**AMENDMENT 12: Maintenance #15:
Power over Ethernet**

Reference number
ISO/IEC/IEEE 8802-3:2021/Amd.12:2022(E)

Amendment 12: Maintenance #15: Power over Ethernet

Abstract: This amendment implements editorial and technical corrections, refinements, and clarifications to Clause 145, Power over Ethernet, and related portions of the standard. No new features are added by this amendment.

Figure 30-3—DTE System entity relationship diagram

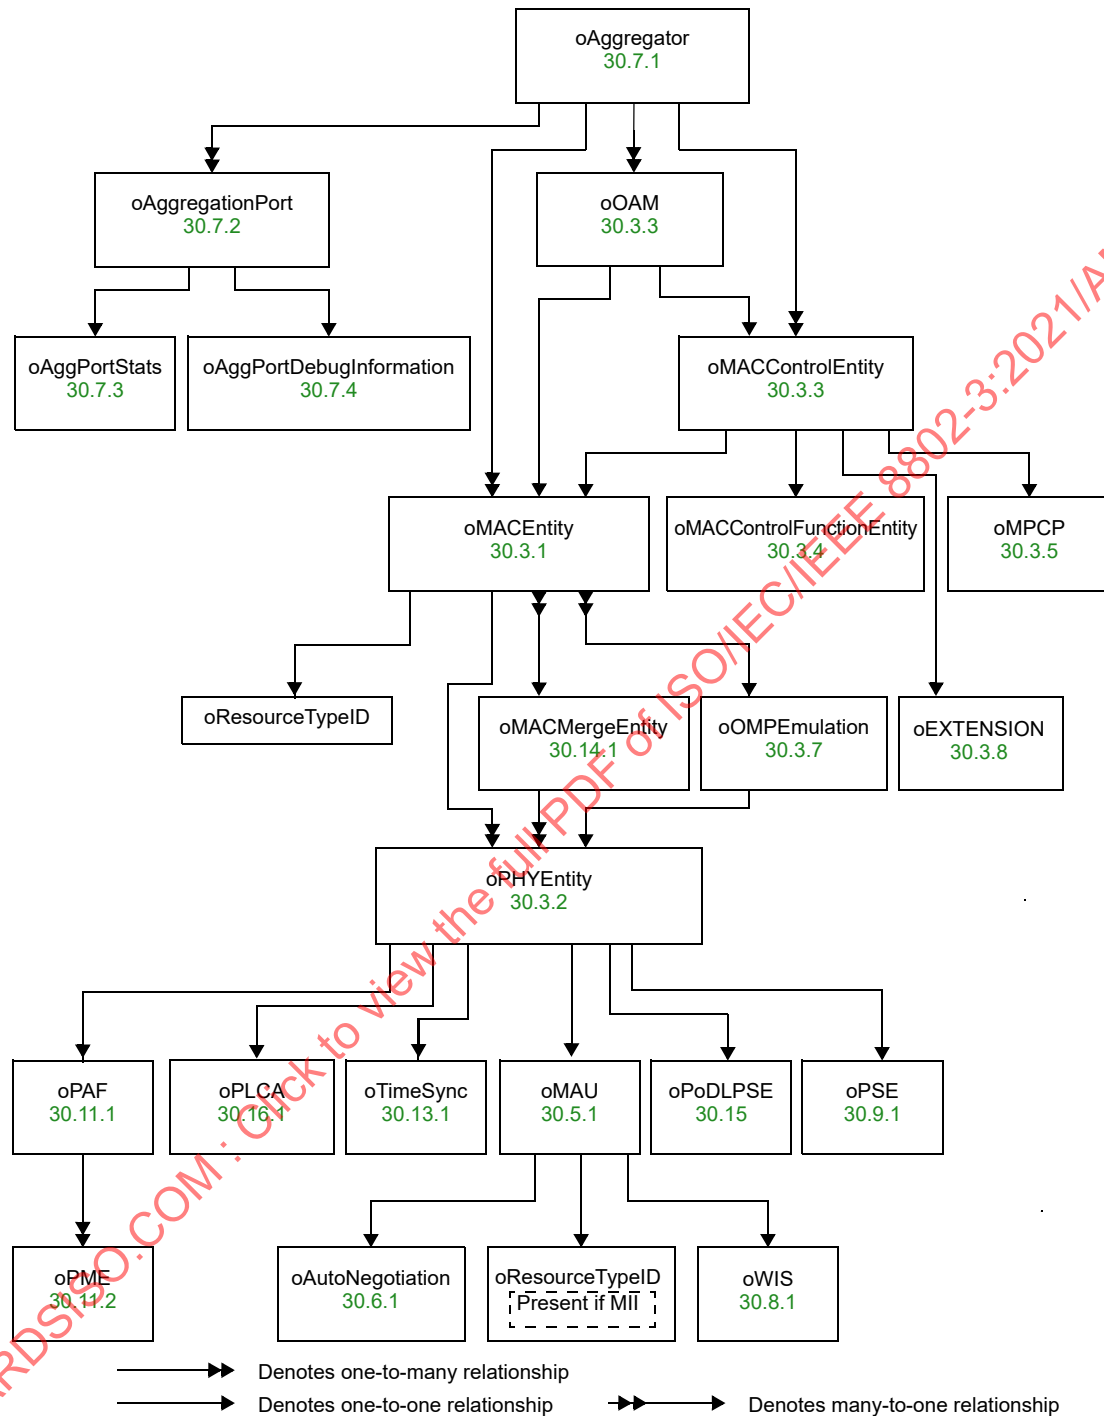
Replace Figure 30–3 as modified by IEEE Std 802.3cg-2019 to remove oPD as shown on the following page.

Figure 145–13—Top level PSE state diagram (continued)

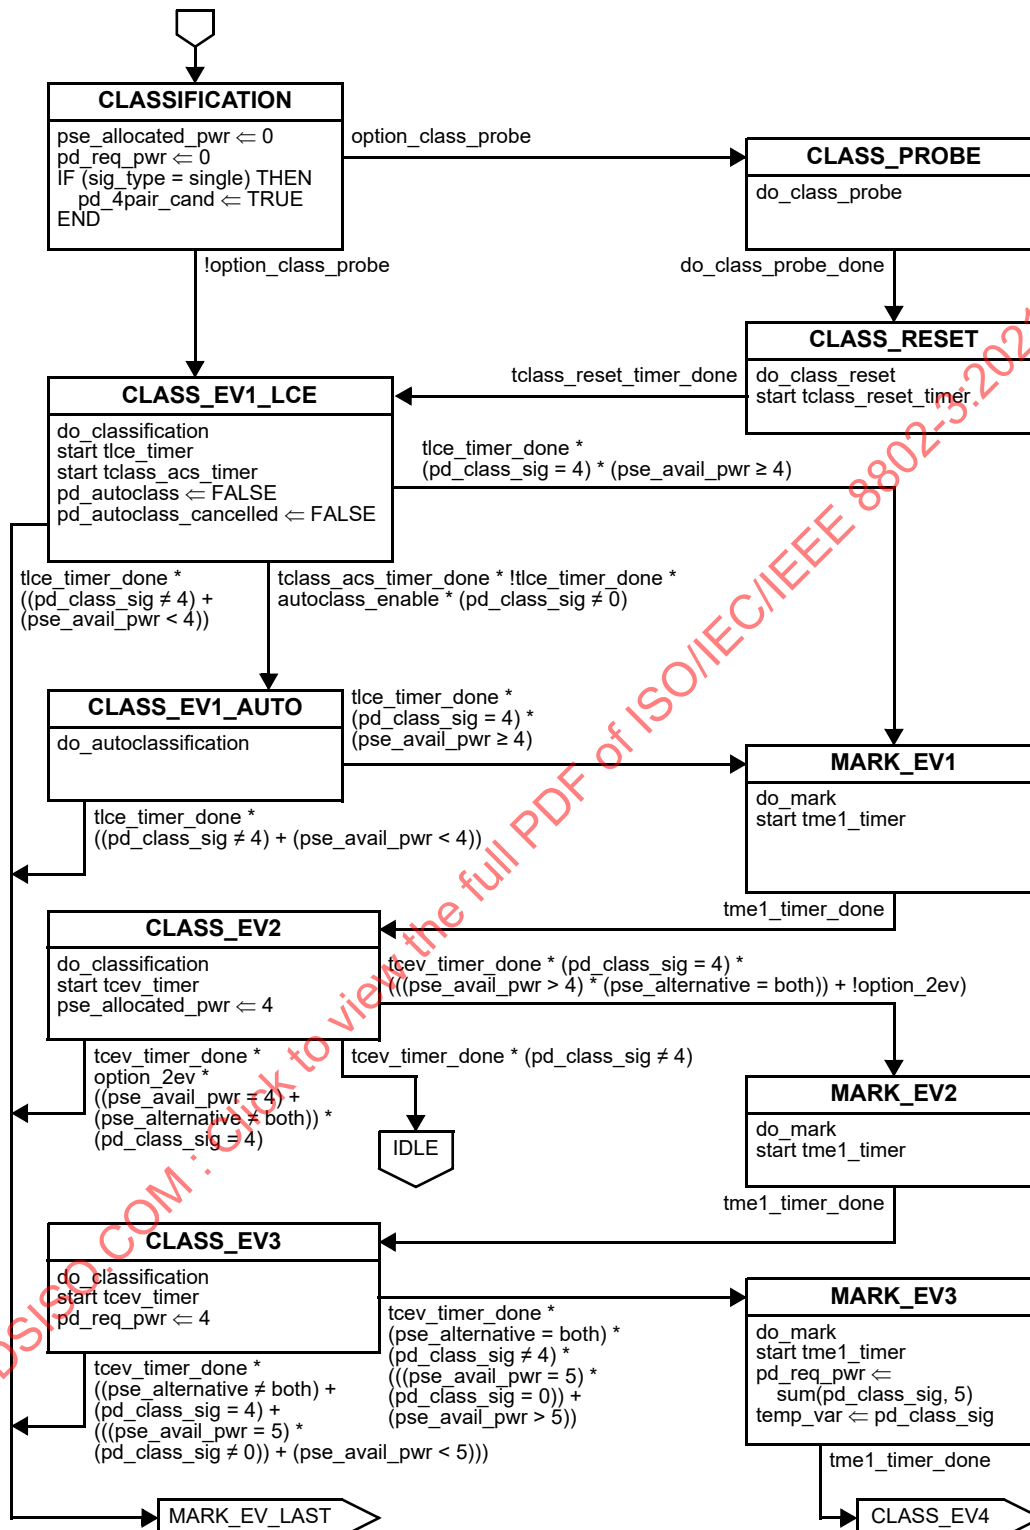
Replace part 3 of Figure 145–13, (with changed content in state `CLASS_EV1_LCE`) as shown on the following page.

Figure 145–14—PSE Autoclass state diagram

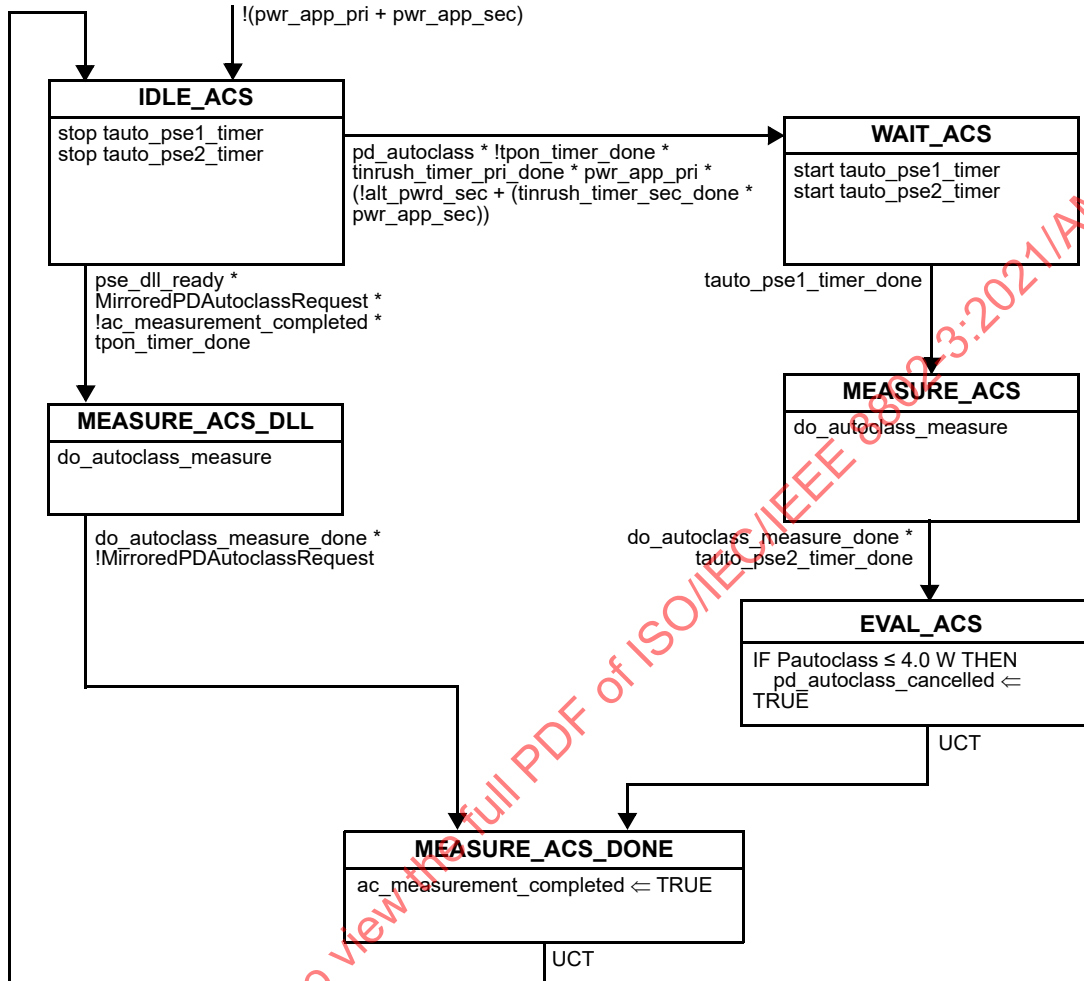
Replace Figure 145–14 with the following figure:

Figure 145–15—Primary Alternative dual-signature semi-independent PSE state diagram

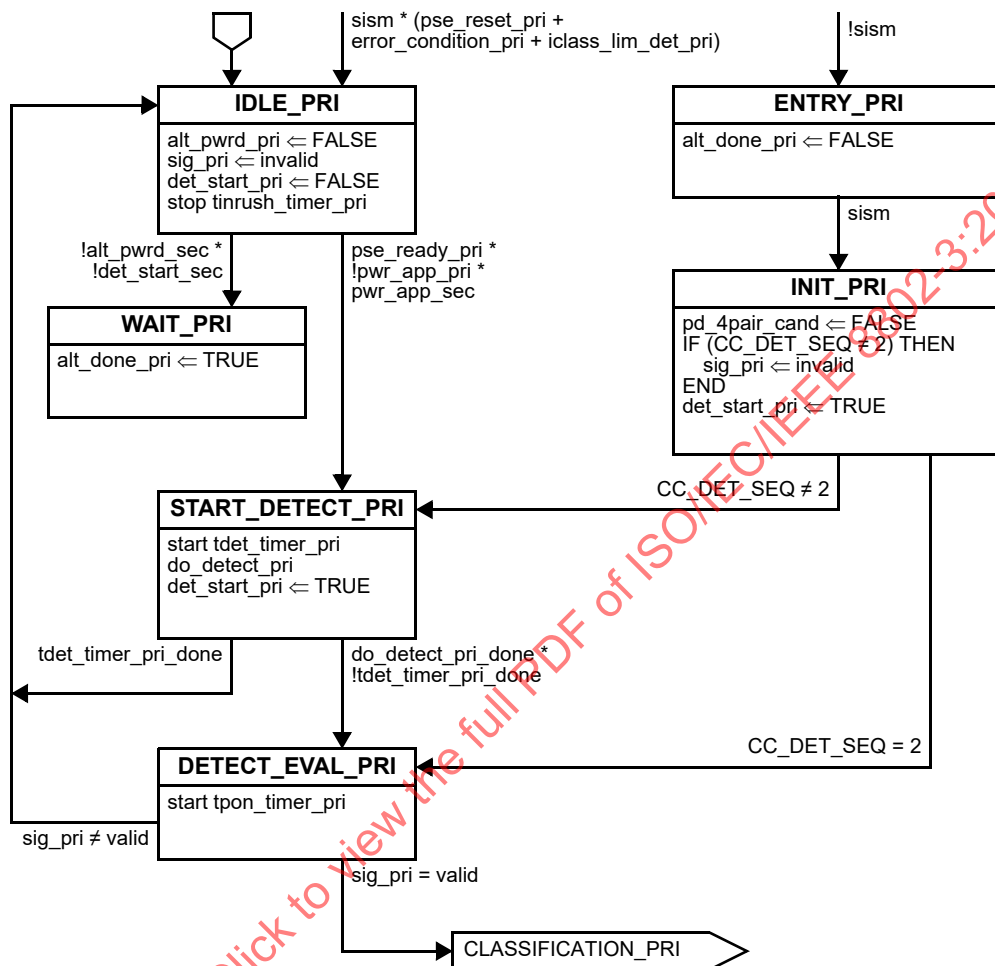
Replace part 1 of Figure 145–15 with the following figure (with changed exit condition from *IDLE_PRI* to *START_DETECT_PRI*):

Figure 145-15—Primary Alternative dual-signature semi-independent PSE state diagram (continued)

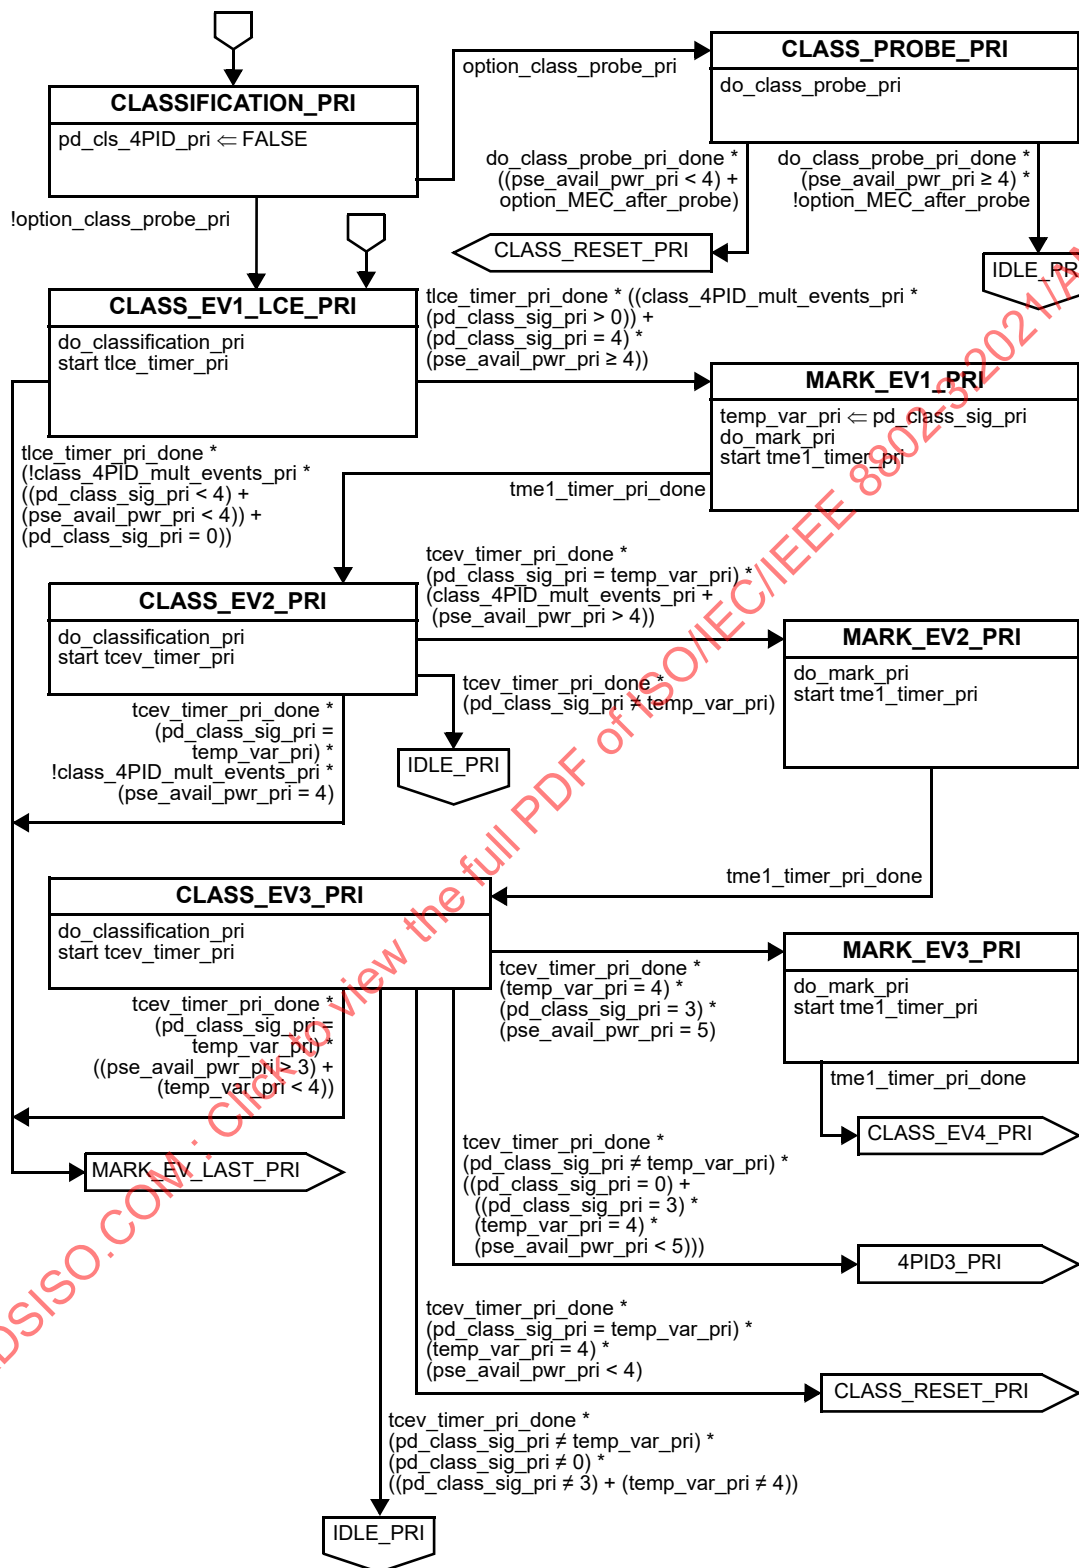
Replace part 2 of Figure 145–15 (with changed exit conditions from *CLASS_PROBE_PRI*) as shown on the following page.

Figure 145–15—Primary Alternative dual-signature semi-independent PSE state diagram (continued)

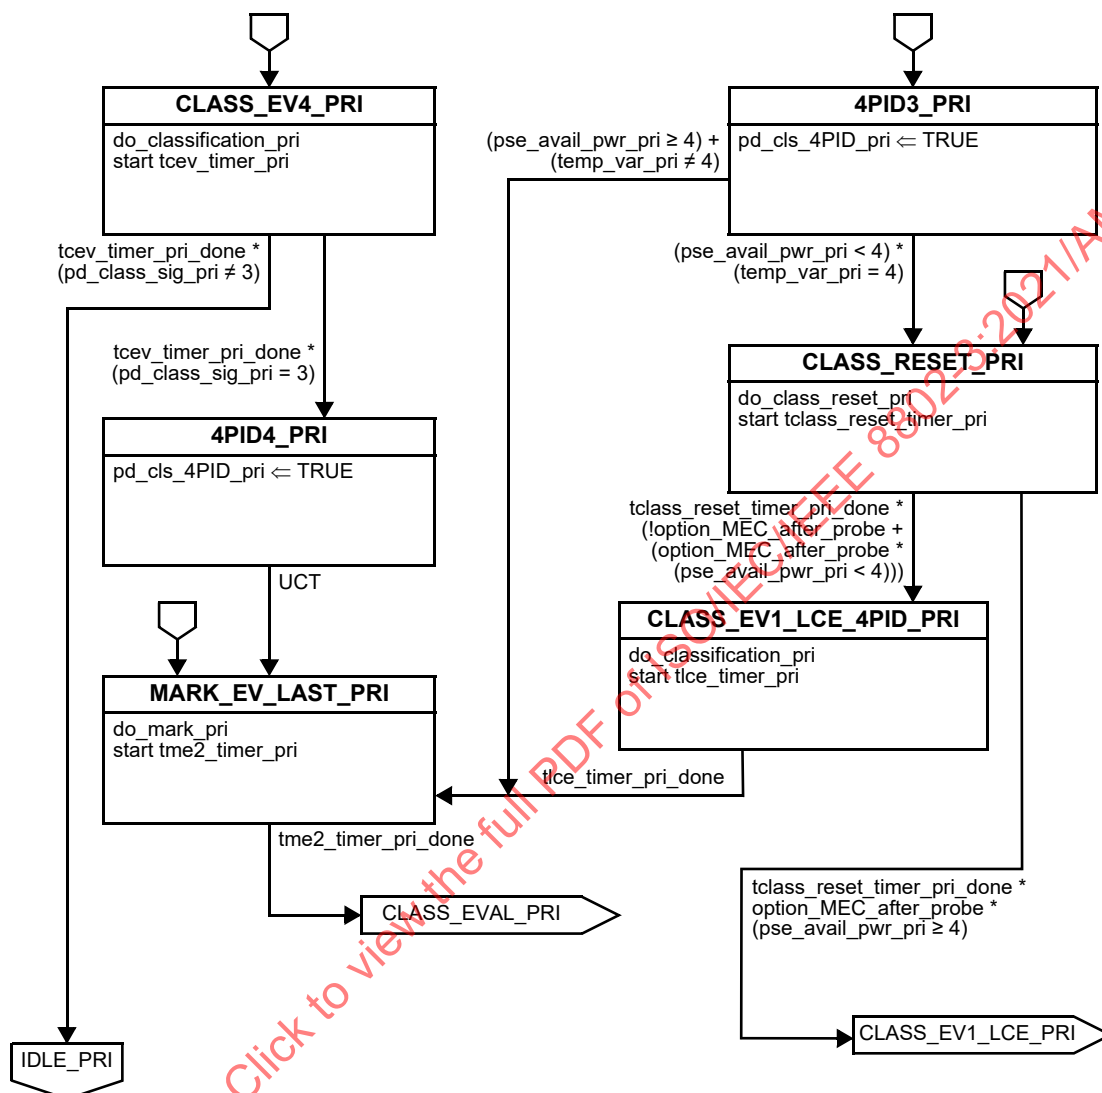
Replace part 3 of Figure 145–15 with the following figure (with changed exit conditions from CLASS_RESET_PRI):

Figure 145–16—Secondary Alternative dual-signature semi-independent PSE state diagram (continued)

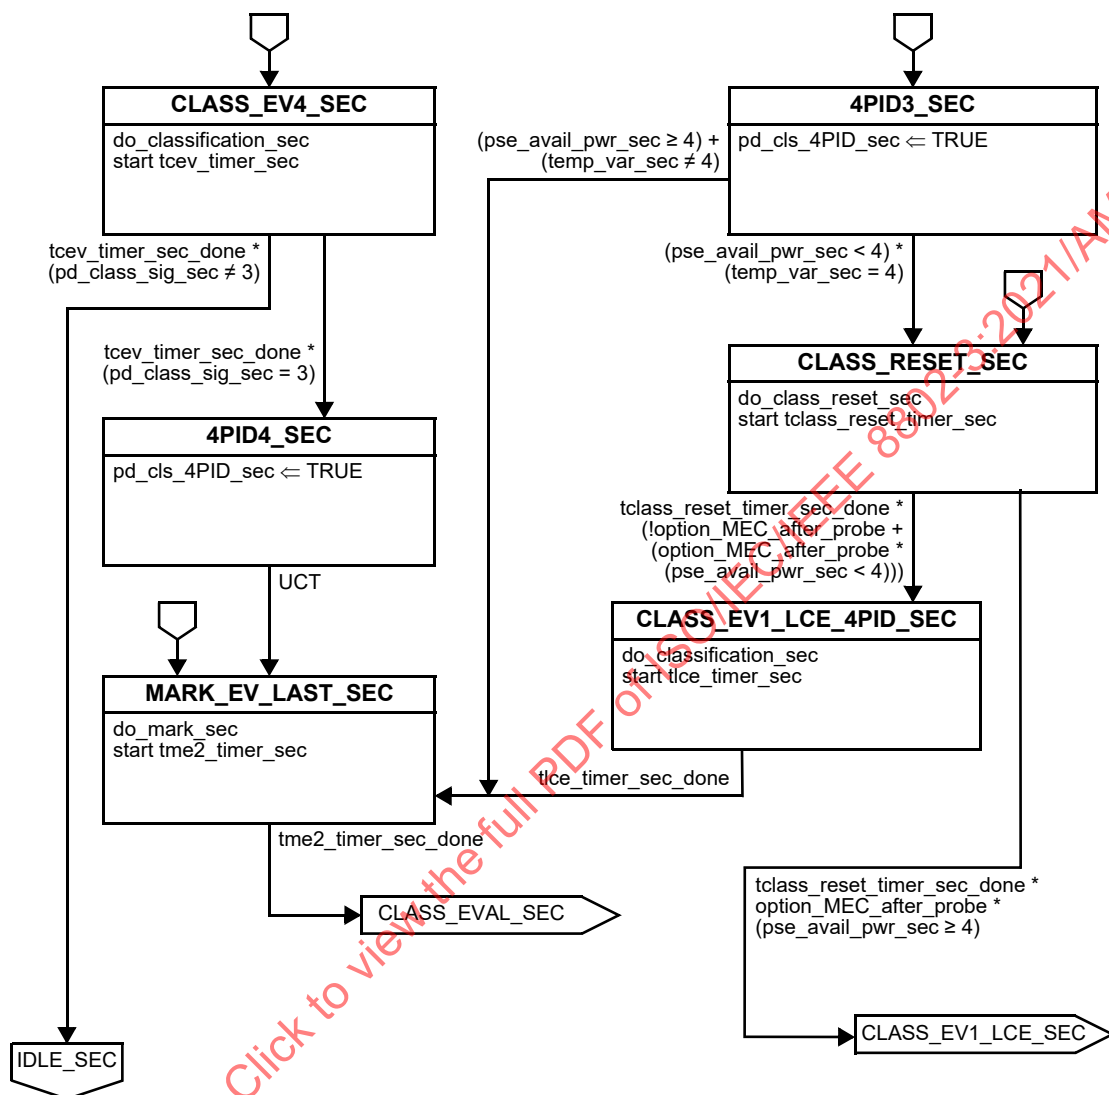
Replace part 3 of Figure 145–16 with the following figure (with changed exit conditions from CLASS_RESET_SEC):

Figure 145–25—Single-signature PD state diagram

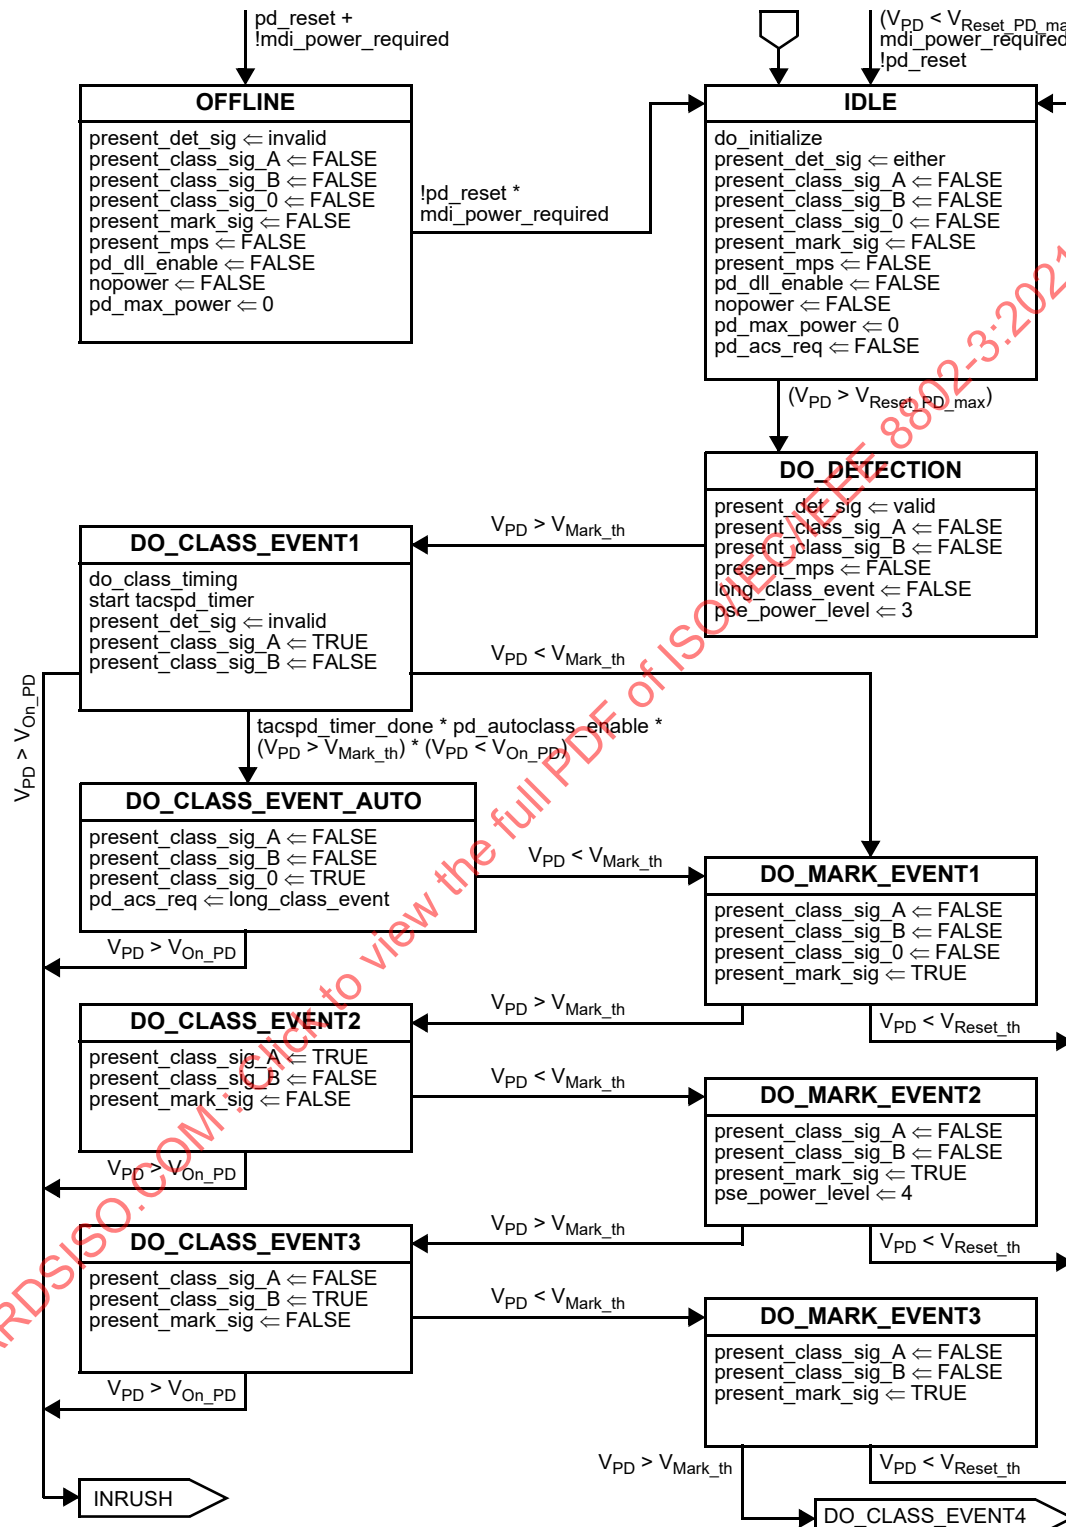
Replace part 1 of Figure 145–25 with the following (with changed content in DO_CLASS_EVENT_AUTO):
